HIROSE ELECTRIC CO., LTD.
5-23, OSAKI 5-CHOME, SHINAGAWA-KU, TOKYO, JAPAN

Product Change Notification

■Product List Business 430-19009_Change lot no. seal method

■ Details of change

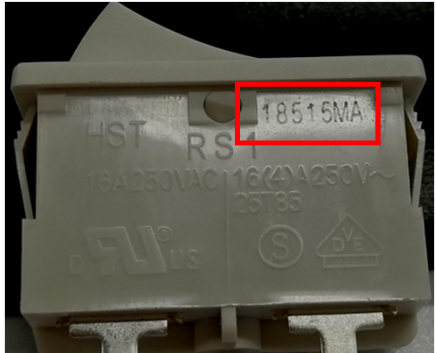
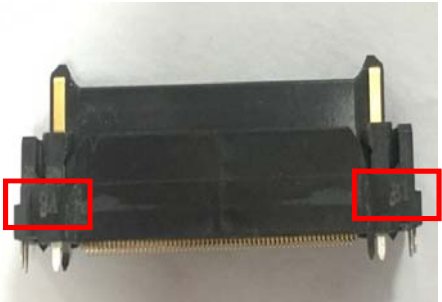
Series	Before change	After change
DM3	 <p data-bbox="363 595 692 622">Display lot no. with ink marking</p>	 <p data-bbox="845 595 1327 622">Display lot no. and HRS logo by laser marking</p>
RS1	 <p data-bbox="363 1066 692 1093">Display lot no. with ink marking</p>	 <p data-bbox="906 1066 1264 1093">Display lot no. with laser marking</p>
FX23	 <p data-bbox="363 1482 705 1509">Display lot no. with heat marking</p>	 <p data-bbox="912 1482 1264 1509">Display lot no. with laser marking</p>
